**CITY OF NOVI CITY COUNCIL**  
**OCTOBER 12, 2020**

**SUBJECT:** Approval of the request from the Living and Learning Center for two variances from Design and Construction Standards including Section 11-239(b) to allow wheel stops in lieu of curbed parking spaces and the use of gravel for vehicular travel and parking, as well as Section 11-256(b) to dismiss the sidewalk requirement along Eight Mile Road and Griswold Street, and to allow no payment into the City's Sidewalk Fund.

**Re:** Variance from Design & Construction Standards  
 Living and Learning Center – No Curbs/Gravel Surface/No ROW Sidewalks

## Request for Variance Design and Construction Standards

| <b>PRELIMINARY SITE PLAN</b>  |  |

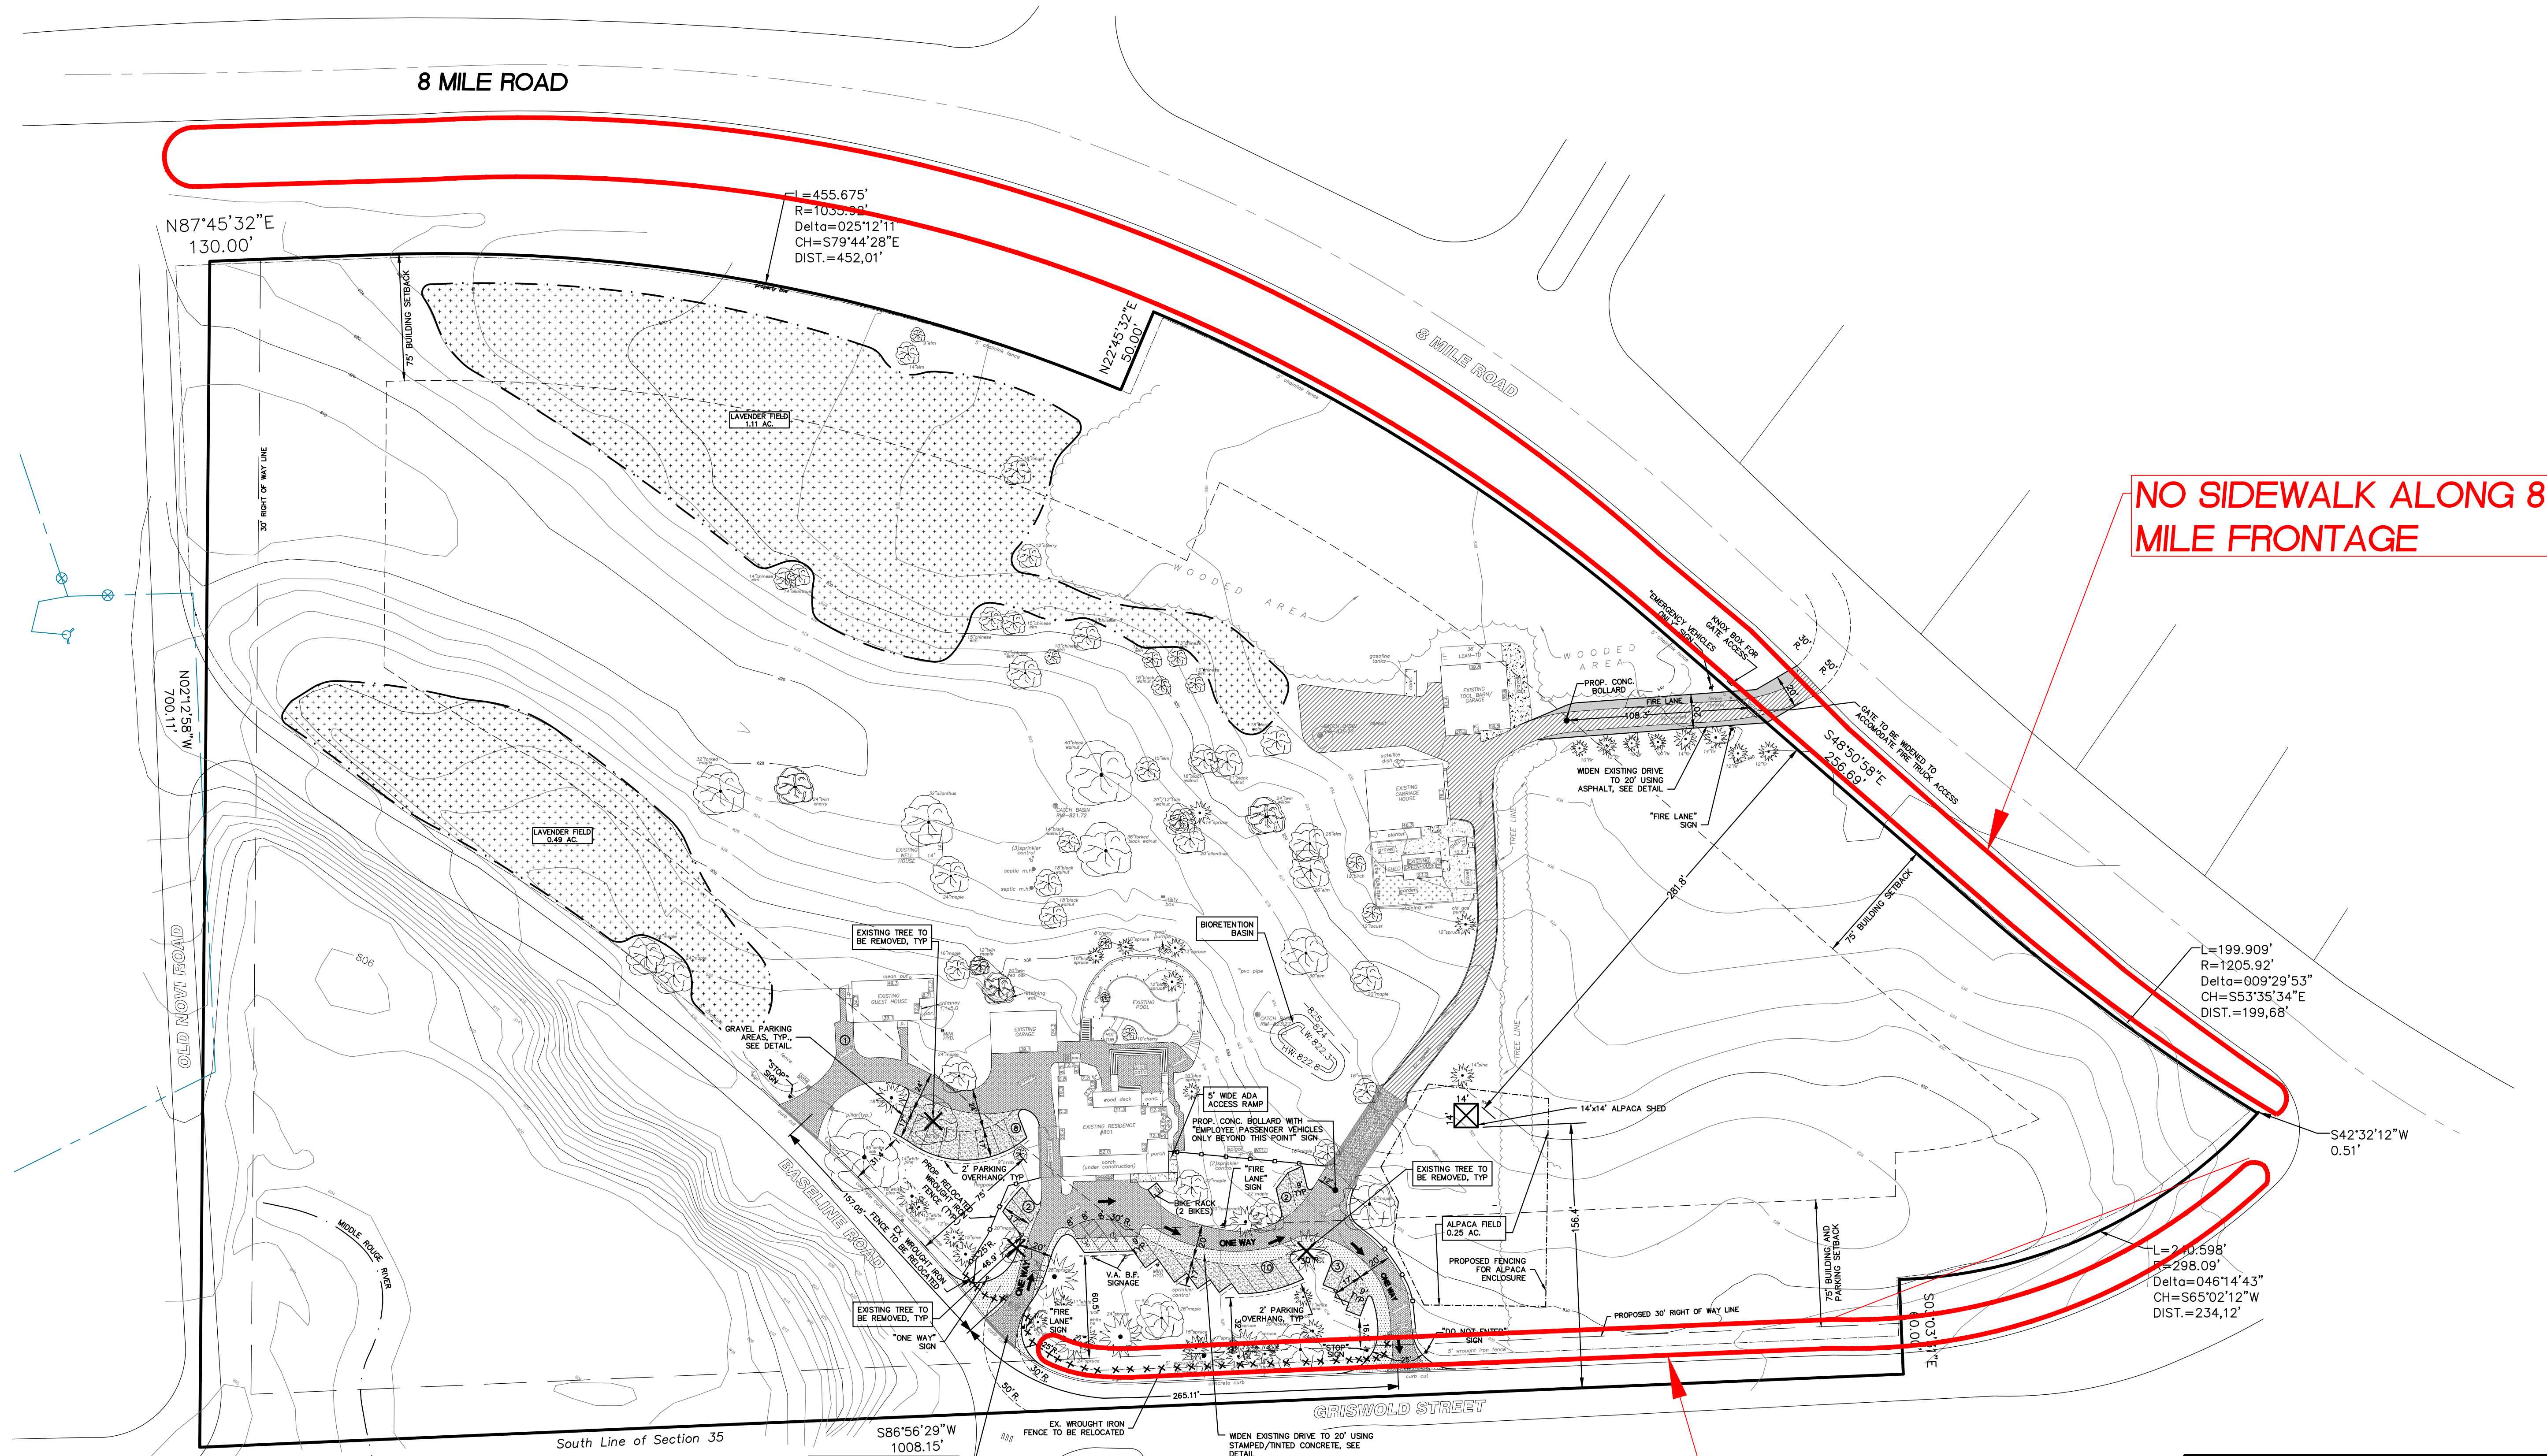
**Non-Motorized Plan:** The Applicant has not proposed to provide sidewalks along 8 Mile Road or Griswold Street as shown in the Non-Motorized Master Plan.

**NO SIDEWALK ALONG 8 MILE FRONTAGE**

**NO SIDEWALK ALONG GRISWOLD STREET FRONTAGE**

*Applicant Response:* The applicant will be requesting a Design and Construction Variance Request for the absence of new sidewalk on the south side of 8 Mile Road and along the north side of Griswold Street. Additionally, the applicant will be requesting a waiver from the City Council to waive payment of the sidewalk construction into the sidewalk fund.

8 Mile Road:

- The proposed site is bordered on the west by the City of Northville and to the south by Northville Township. Providing a sidewalk on the south side of 8 Mile Road will not provide a tangible connection to the existing City of Novi sidewalk system or provide any connections to existing sidewalk systems in the City of Northville or Northville Township.

- 8 Mile Road to the west of the site crosses over an existing railroad by a highway bridge. The existing bridge does not currently provide adequate room for pedestrian crossings on the north or south side of the bridge. Extending a sidewalk along 8 Mile Road to the west side of the property will result in a dead end sidewalk. It should be noted that the existing City of Novi sidewalks on the north side of 8 Mile Road also do not extend to the bridge crossing. Rather, the sidewalk turns north along Brickscape Drive. Additionally, 8 Mile Road ramps upward significantly at the north west corner of the site to accommodate the bridge crossing. The road is approximately 25 feet higher than the north east property corner of the LLEC property. This would require a considerable amount of fill for sidewalk construction and potential relocation of existing bridge approach barrier rails. A sidewalk in this area does not appear feasible.

- It should be noted that there are no sidewalks located on the south side of 8 Mile Road within Northville Township until east of Meadowbrook Country Club (Approx. 1.4 Miles east)

Griswold Road:

- Similar to 8 Mile Road, there are no existing sidewalk systems on either side of Griswold Road to connect to extending south into Northville Township. The nearest sidewalks along Griswold Road are approximately 1,400-1,500 ft to the south as you enter the City of Northville.
- There is currently an existing pedestrian crossing stub over 8 Mile Road on the south side of Griswold Street without a sidewalk connection to this stub. Adding a sidewalk on the north side of Griswold Road will not connect this pedestrian crossing stub. Additionally, there is not currently a pedestrian crossing or signalization to the north side of Griswold Street at the 8 Mile intersection. We do not anticipate that LLEC clients will walk to our facility, as we serve people from across the Metro Detroit area and do not specifically serve clients in the immediate area surrounding our facility.
